KM 175

END CLUTCH SHAFT AND INPUT SHAFT MODIFICATIONS

Figure 1

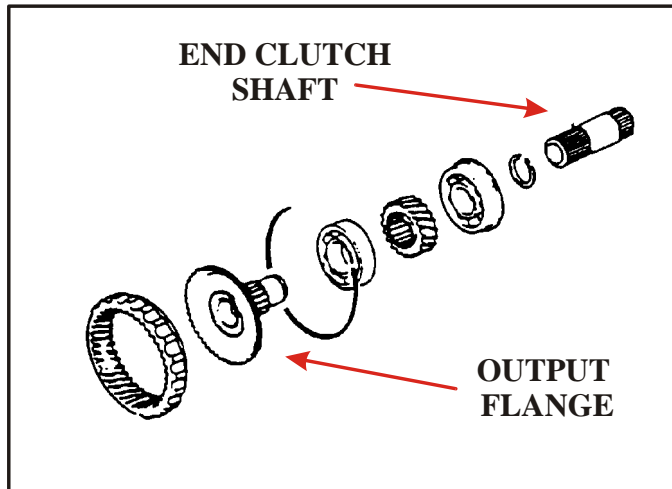
A series of changes have been made to the end clutch shaft, output flange assembly and input shaft (Figures 1 and 2) of the KM177 automatic transaxle used in 1988 Galant Sigma vehicles. These changes have been made to improve the lubrication capability and wear resistance of these components. When servicing the KM177 transaxle, be aware of these differences.

Figure 2

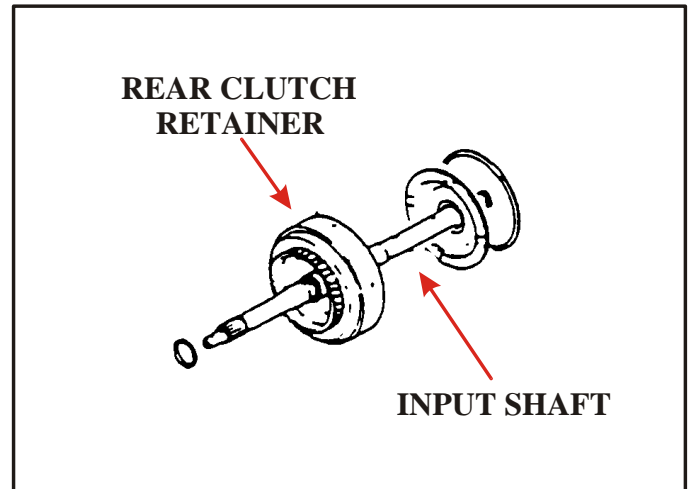
If hard shift symptoms are exhibited, remove the servo piston assembly from the transaxle and check the piston bore (transaxle case) for wear (Figure 2). If the bore wear is less than 0.023 in. (0.5 mm), the hard shift symptoms can be improved by installing a D-ring repair kit (P/N MD728665). This kit contains a rubber piston seal ring instead of the carbon material seal ring installed at the factory (Figure 3).

Figure 4

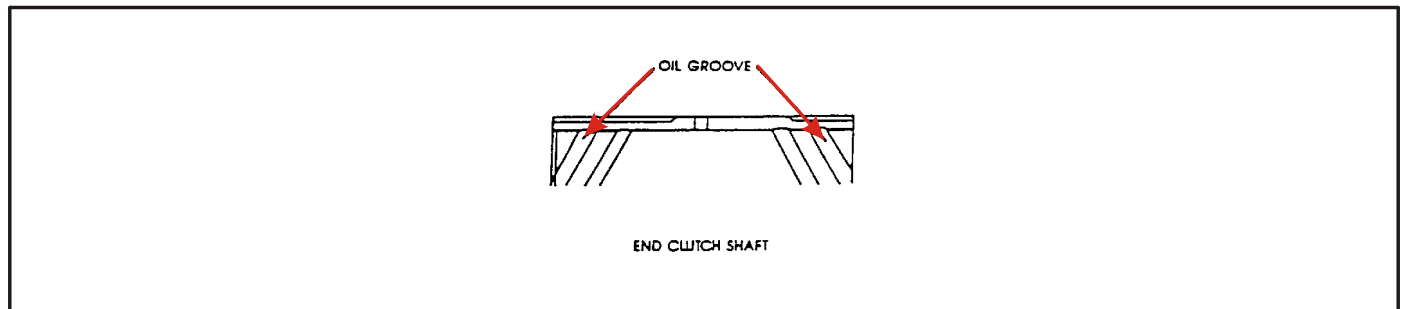
End Clutch Shaft — To improve lubrication of the output flange bushing, a spiral oil groove has been added to the inner diameter of the end clutch shaft as shown in Figure 4 below. This change was effective from August 1987 production (from transaxle number DL6587).

Figure 5

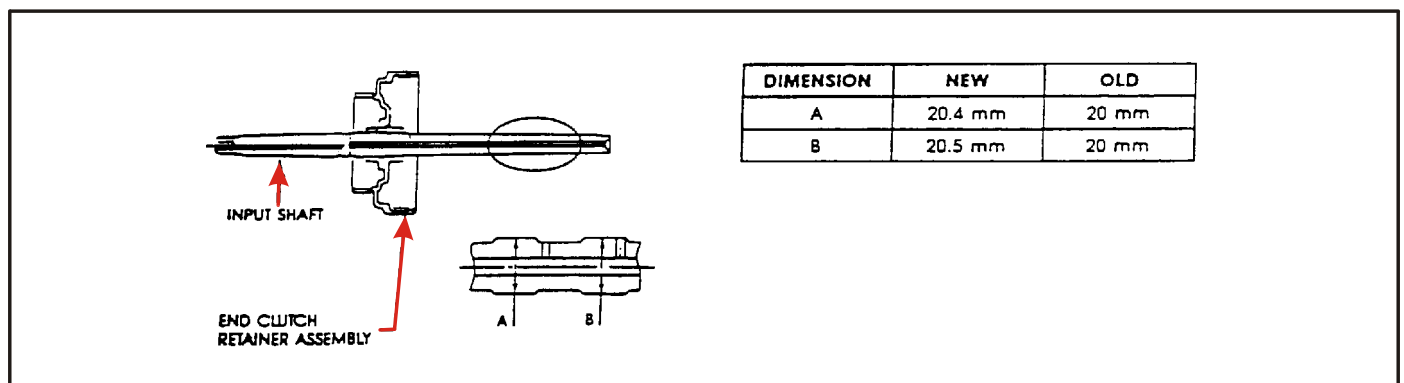
Input Shaft — To improve lubrication at the output flange bushing, the outer diameter of the input shaft (rear clutch retainer assembly) has been increased at two locations as shown in Figure 5. This change was effective from October 1987 production (from transaxle number DS9008).

Figure 6

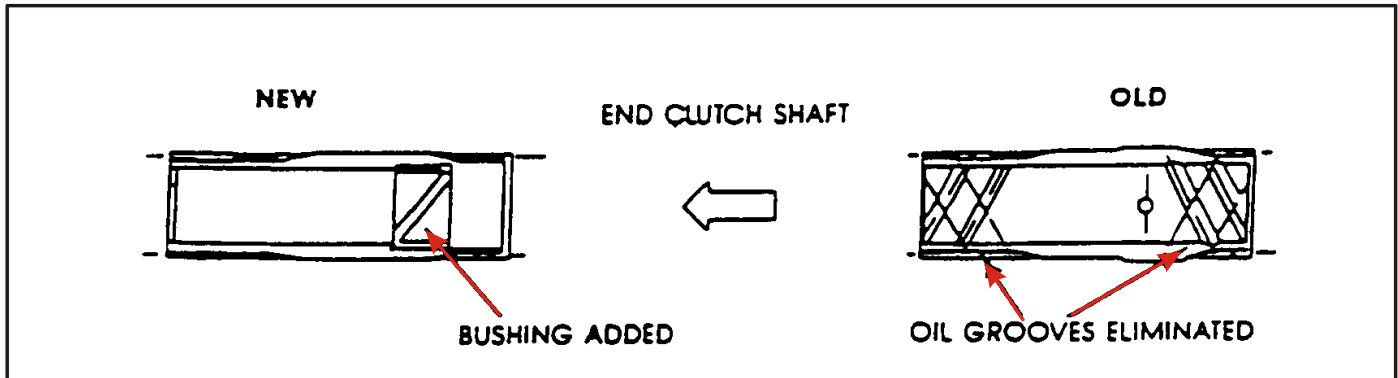
End Clutch Shaft — On the inside of the end clutch shaft, the oil grooves have been eliminated and a bushing has been added to improve wear resistance as shown in Figure 6. One bushing inside the output flange assembly has been eliminated as shown in Figure 7. These changes were effective from November 1987 production (from transaxle number DW3442).
